WELL NO. Turkey Knob #3 API NO: 43-017-30078

APPLICATION FOR PERMIT TO DRILL, DEEPEN, OR PLUG BACK

SUBJECT: APD supplemental stipulations

Usual Environmental Analysis

Fulton Oil & Gas, Inc. Reno, Nevada	
Well Site Plan No. 3 Turkey Knob Sec. 9, T 32 S, R 12 E Garfield Co., Utah	
CLARK-REED & ASSOC. DENVER, COLORADO	DATE Feb. 21, 1978 FILE NO. 78010

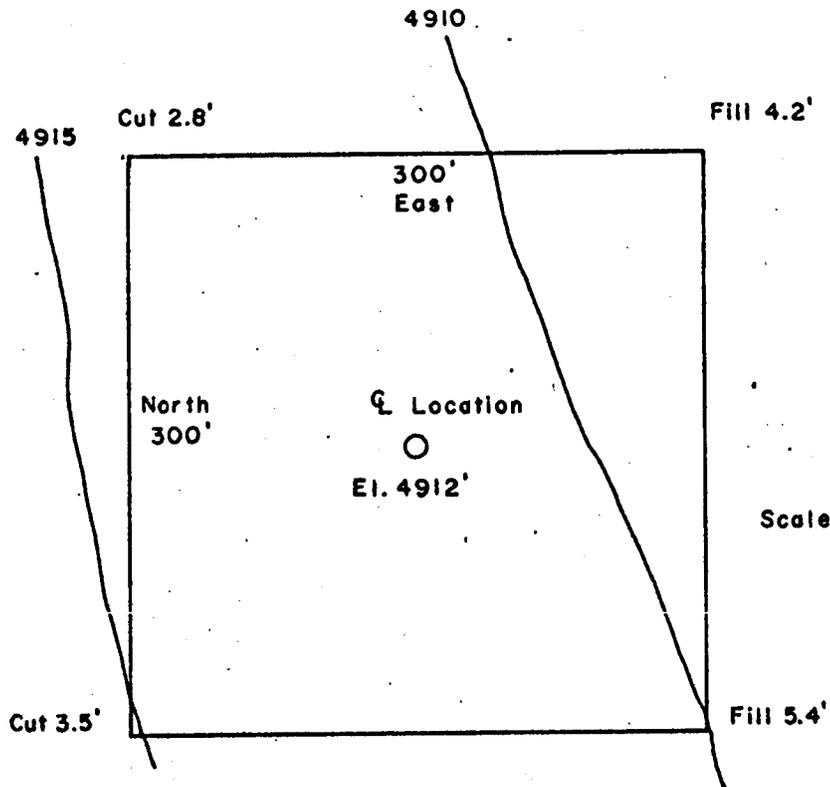
- 1. Reserve pit will be lined.
- 2. A Blooey pit will be constructed and placed at least 120' from the well head.
- 3. The Reserve pit will be fenced on three sides prior to drilling activities and completed when drill rig moves out. The fence will be maintained till the reserve pit dries and reclamation procedures started. Reserve pit 100' x 150'.

FULTON OIL & GAS, INC.
 TURKEY KNOB No. 1
 Sec. 23, T31S, R12E SLM.
 Garfield County, UTAH
 PROPOSED RIG LAYOUT

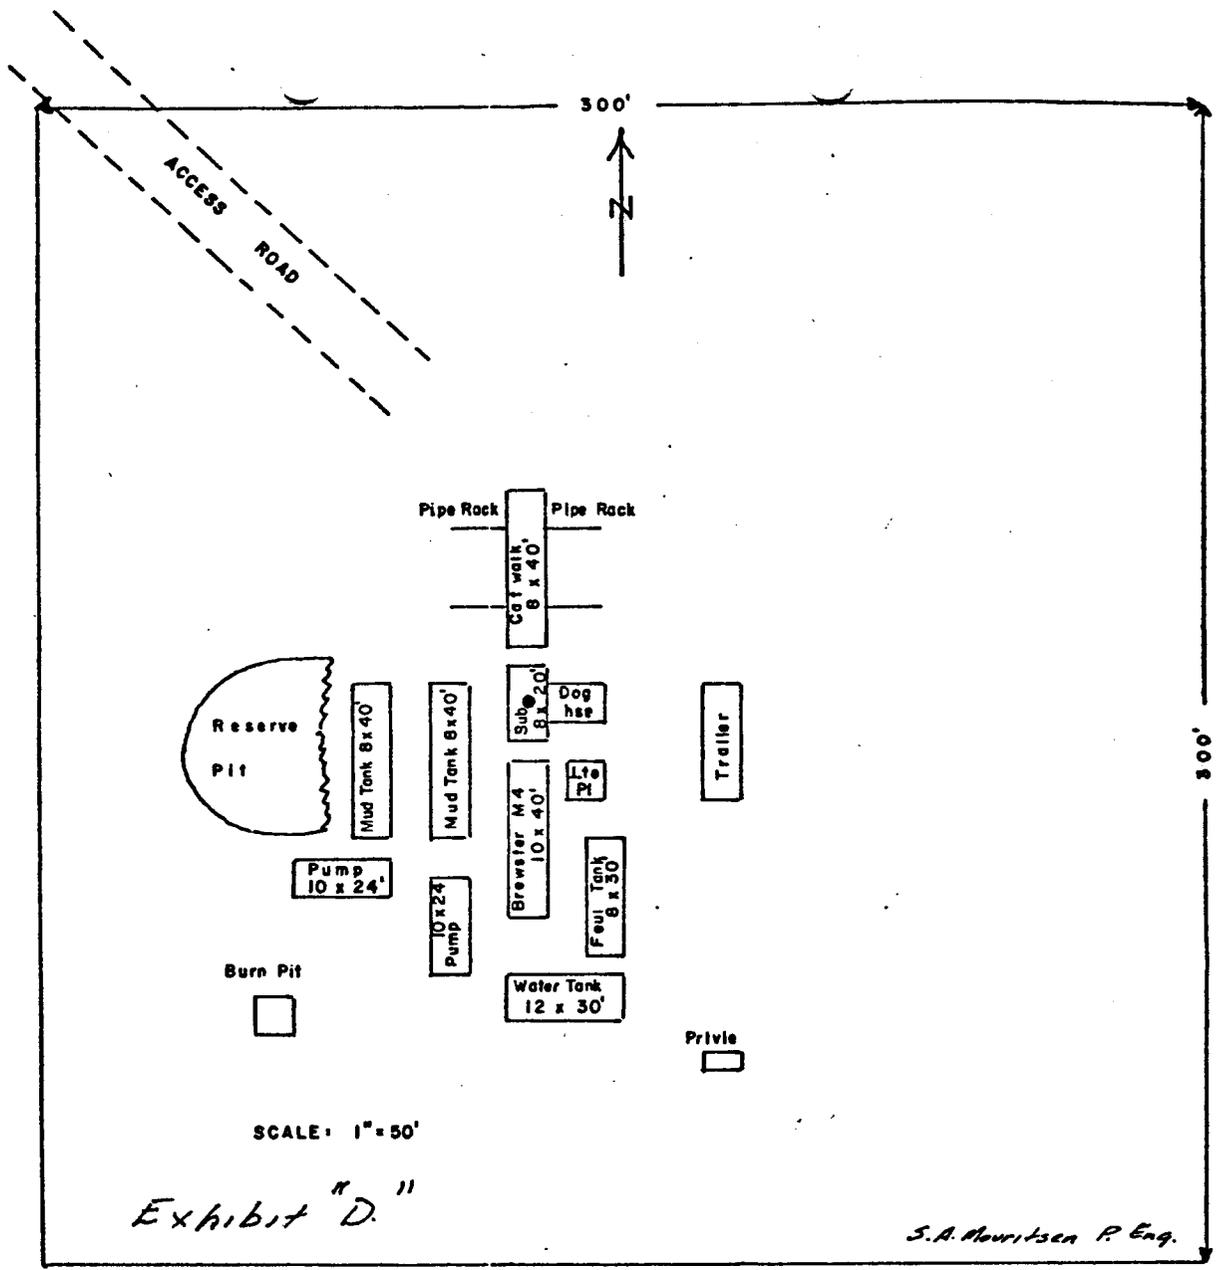
Modified Rig layout
 per joint onsite
 May 16, 78
